**MONTGOMERY COUNTY HISTORIC PRESERVATION COMMISSION**  
**STAFF REPORT**

<b>Address:</b>	11650 Snowden Farm Pkwy., Germantown Formerly 22022 Ridge Rd.	<b>Meeting Date:</b>	9/3/2025
<b>Resource:</b>	Master Plan Site #13/19 <i>Howes Farm</i>	<b>Report Date:</b>	8/27/2025
<b>Applicant:</b>	NECC	<b>Public Notice:</b>	8/20/2025
<b>Review:</b>	HAWP	<b>Tax Credit:</b>	n/a
<b>Permit Number:</b>	1109684	<b>Staff:</b>	Dan Bruechert
<b>Proposal:</b>	Demolition and reconstruction of barn/accessory building

# Responses to HPC Comments/Recommendations during the consultation meeting held July 9, 2025

DRAWING TITLE  
SECTION

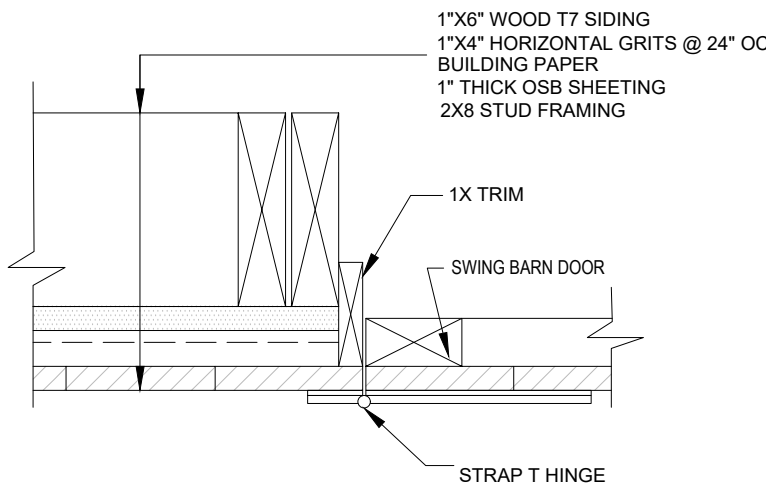
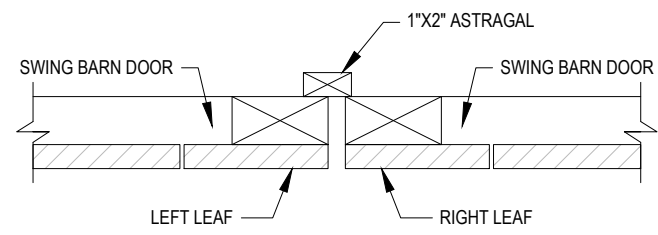
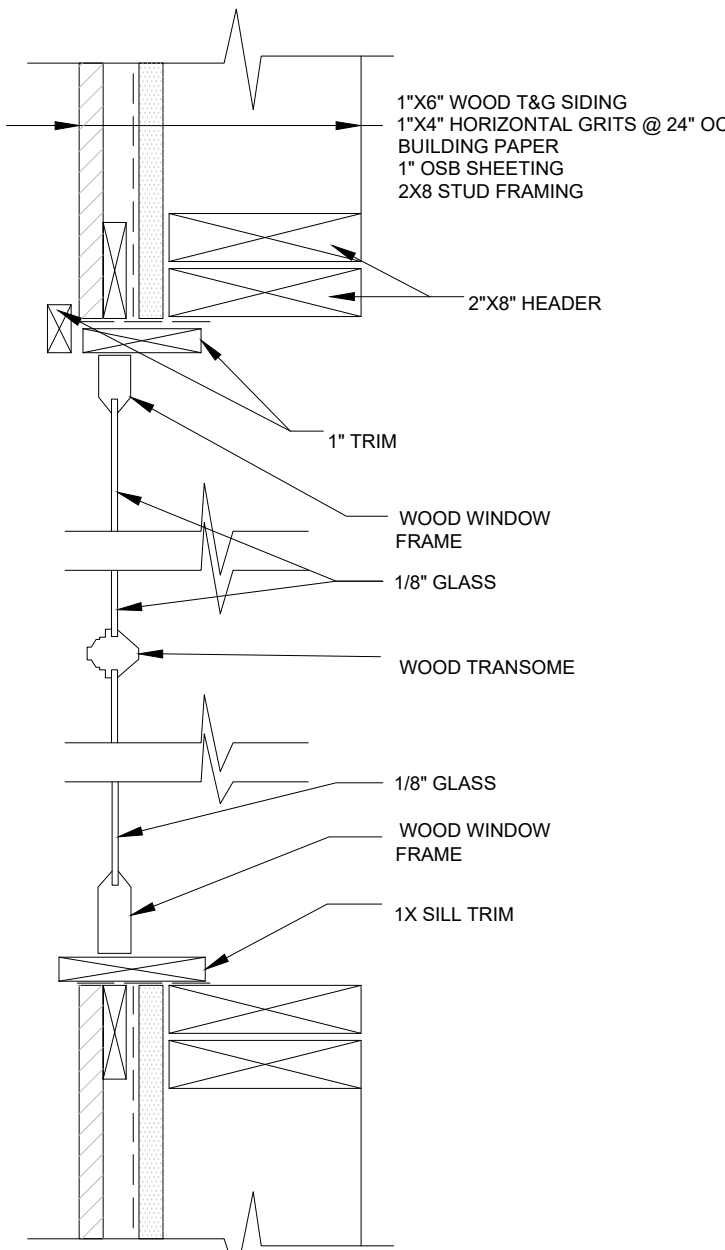
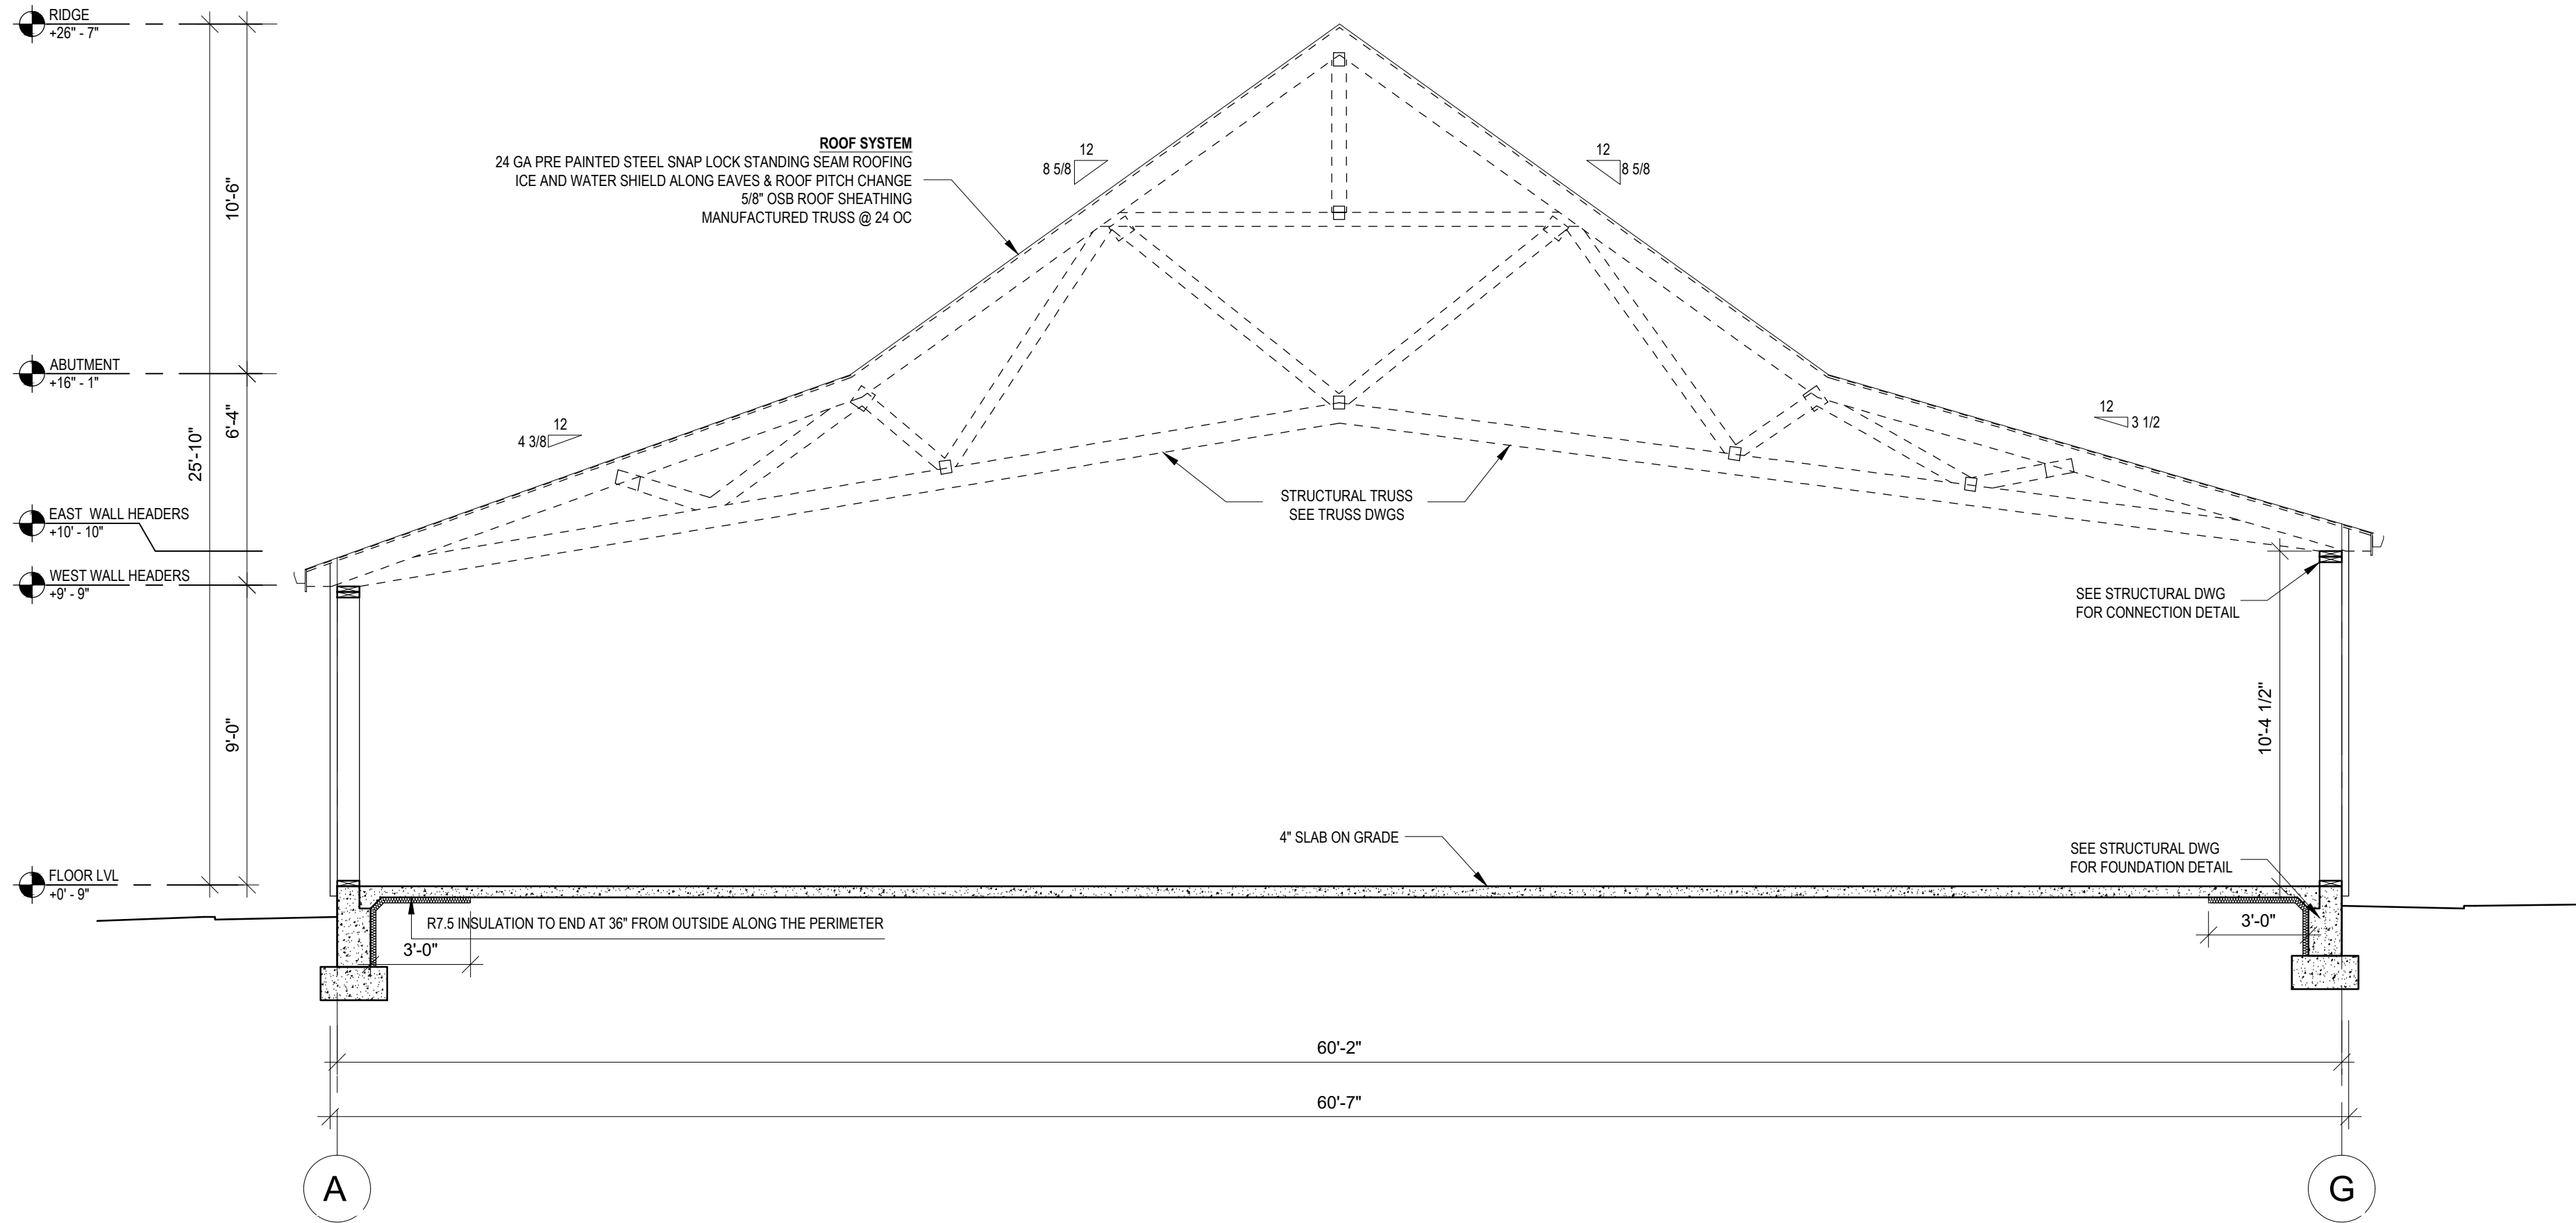
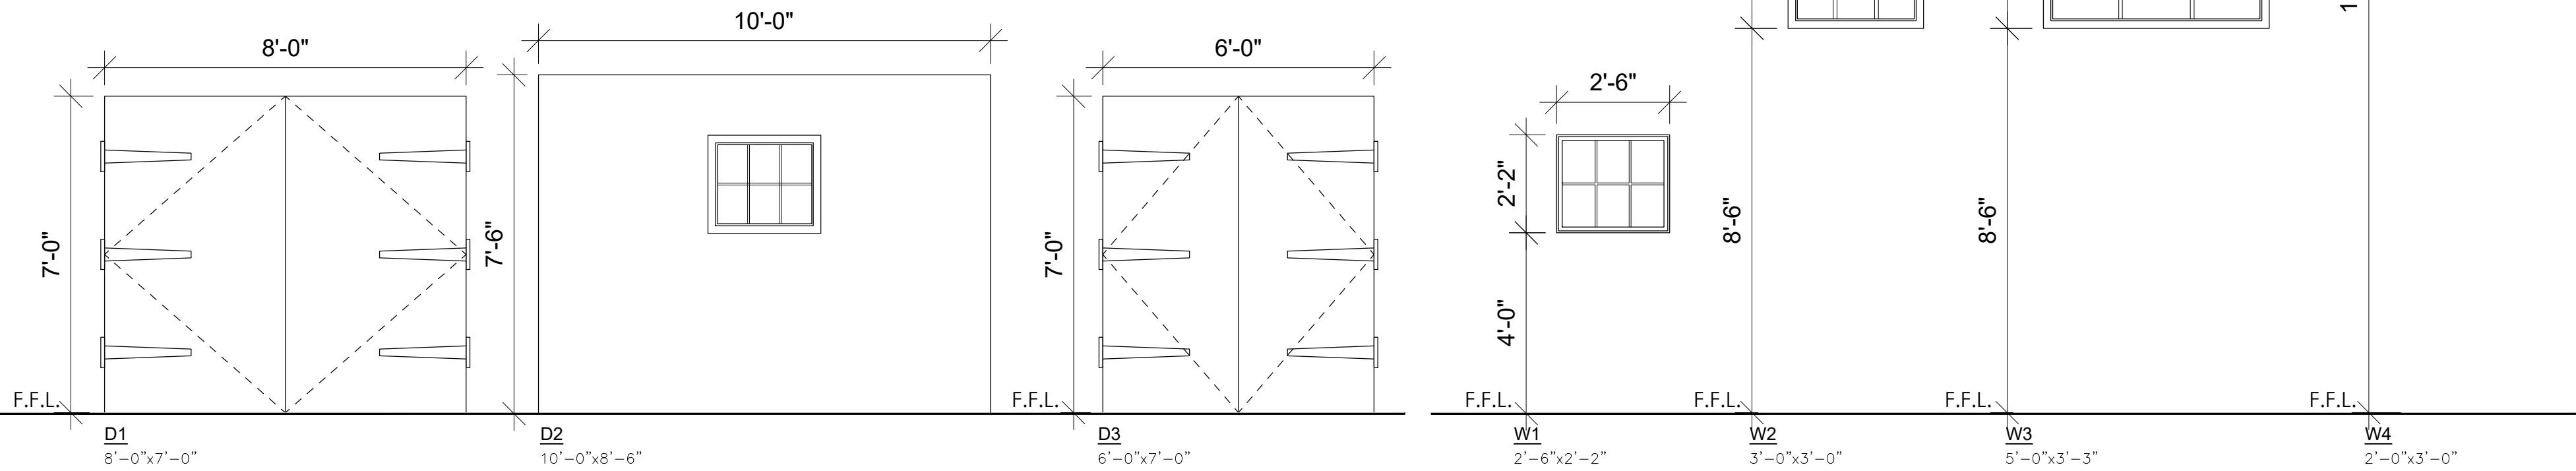
## HPC Comment 3: Windows and Doors

NECC: We have verified that the dimensions in the drawing correspond to those of an existing window. Please refer to drawing sheet A6 for detailed window and door dimensions and specifications.

- Doors /windows details are provided with this submittal, refer the sheets A4, A5, and A6 for details.
